## **ADDENDUM NO. 2**

## **NCSU** Renovations to the Don Ellis Building

SCO ID# 19-21547 NCSU ID# 201920037 SFK PROJECT NO. 1368-20

**December 13, 2023**

A-300

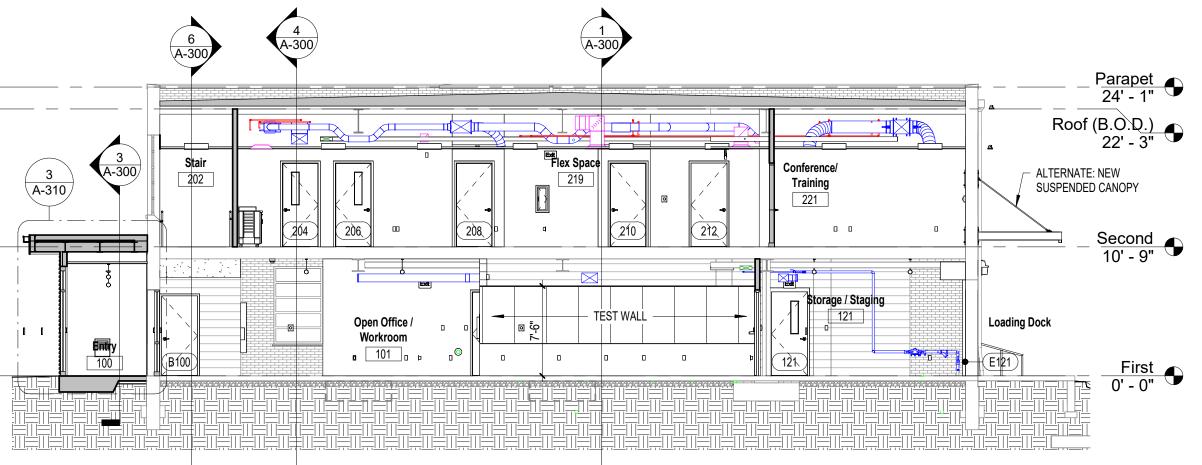
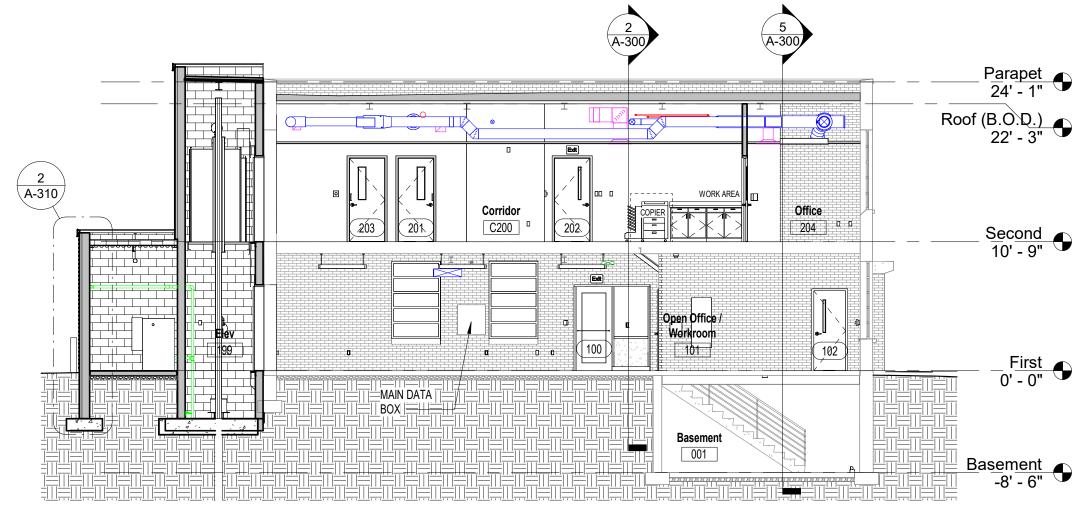
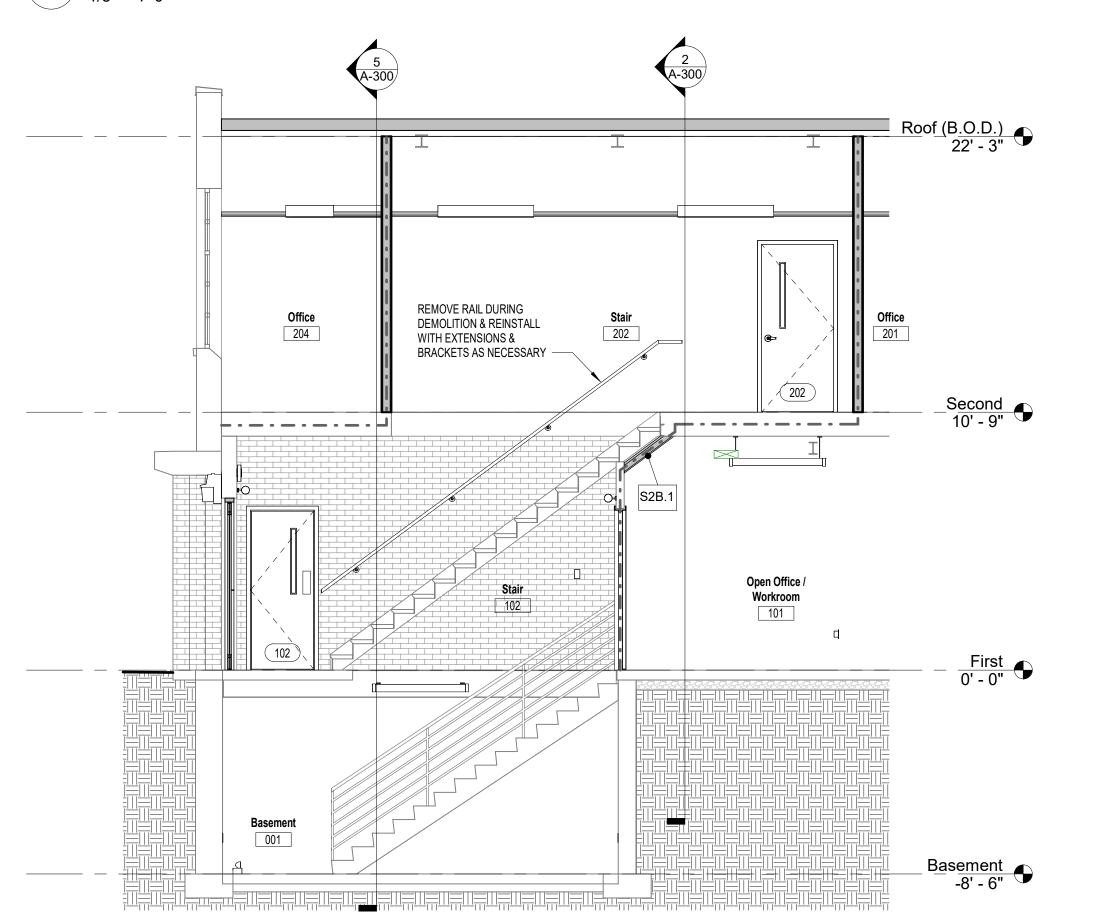
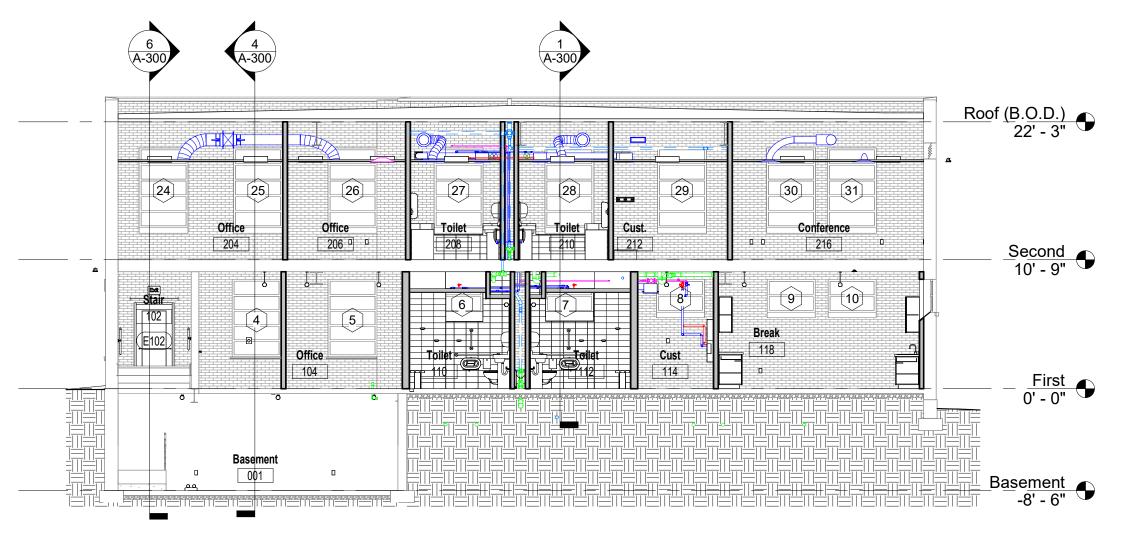
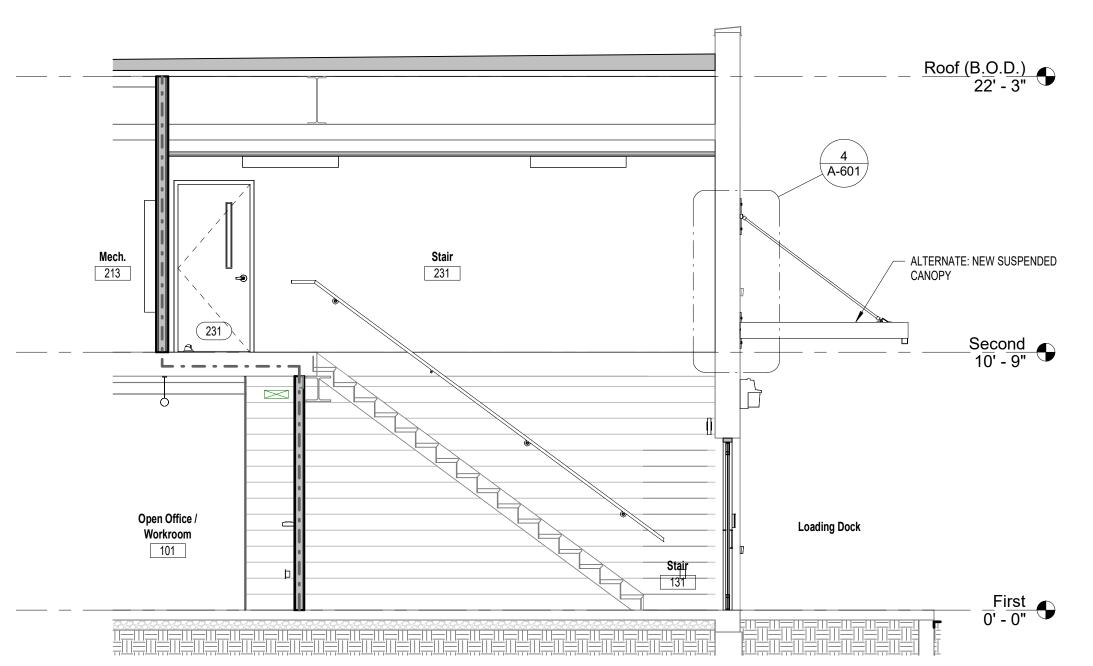
- d. Notes for sealant replacement and painting at existing steel lintels and coal chute.
- 6. Sheet A-300: Replace with sheet A-300 attached
  - a. Minimum clearance for duct work shown in section 1.

**E-200**

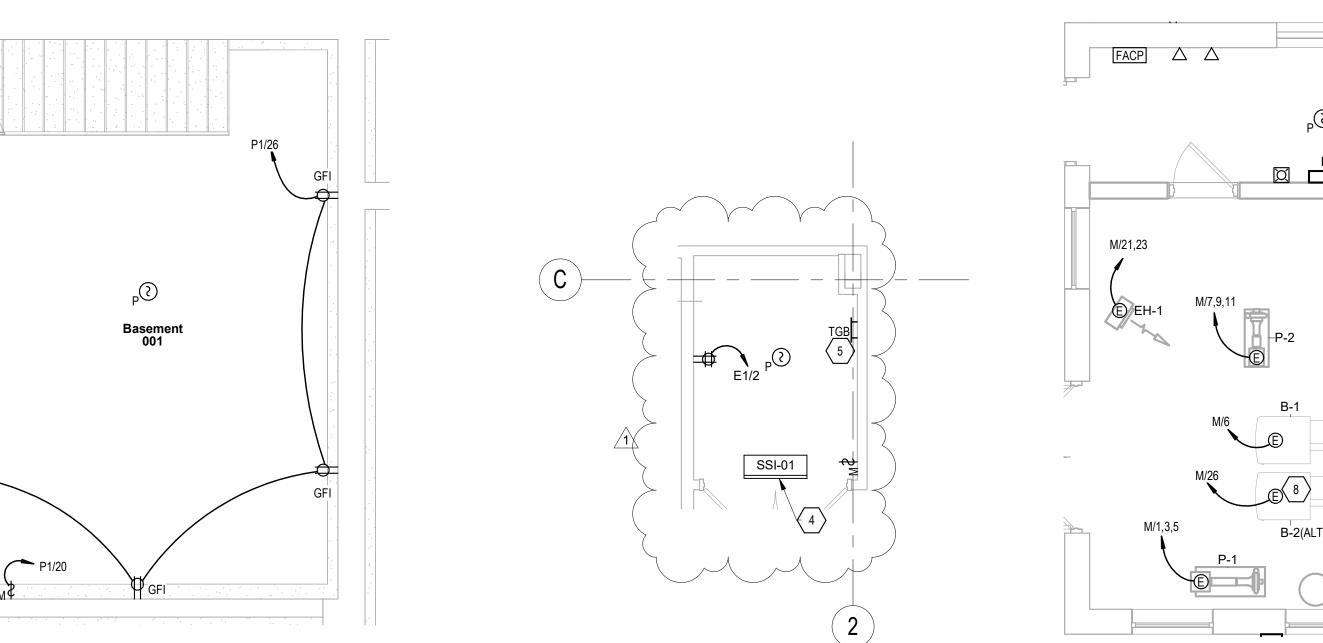
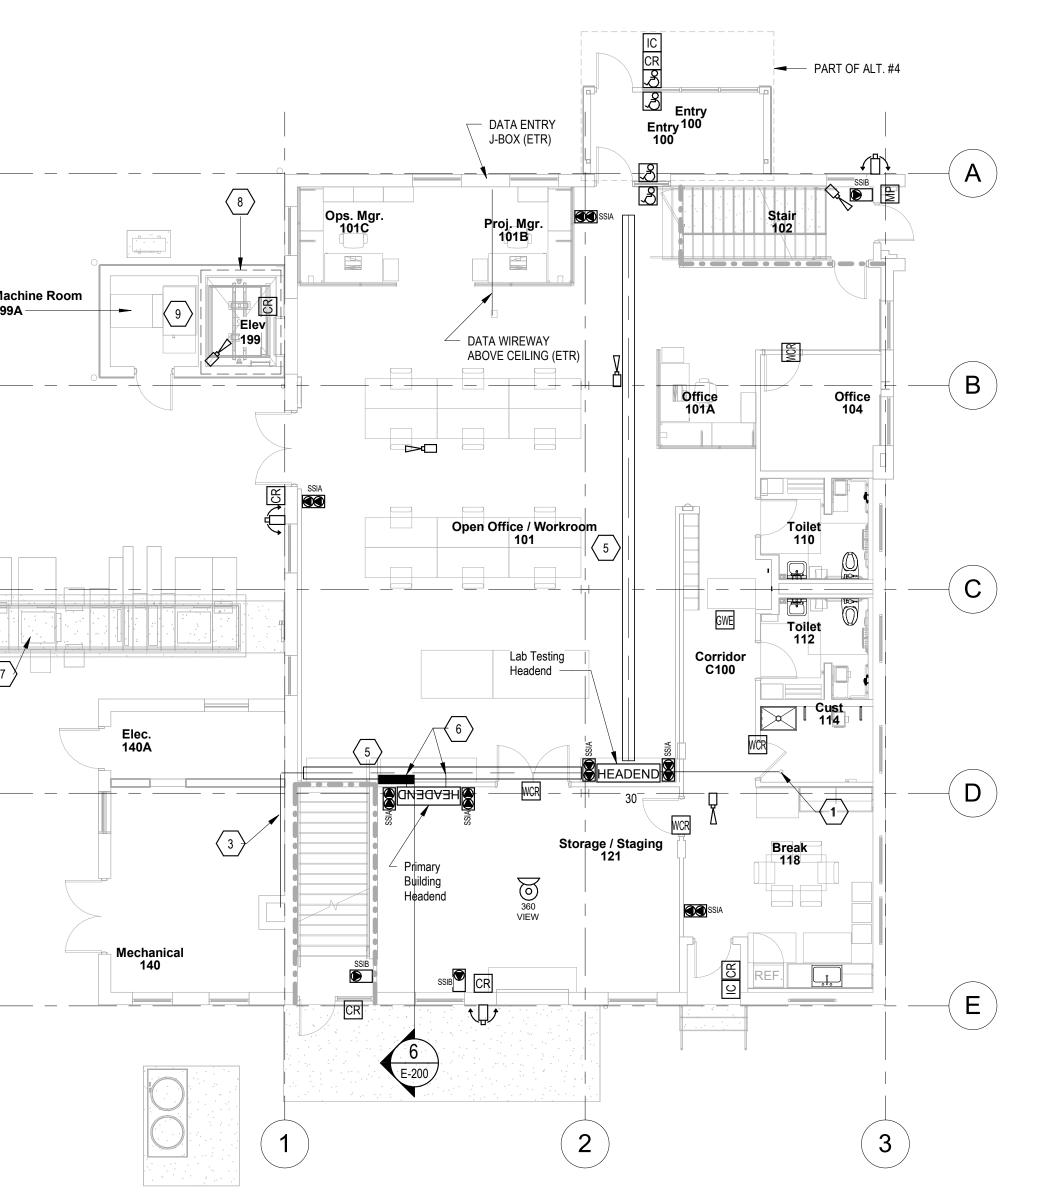
- 12. Sheet E-200: *Replace* with sheet E-200 attached.
  - a. See revised drawing E-200, detail #6 and keyed note 15 for changes to include the new overhead feed and a new weather head.
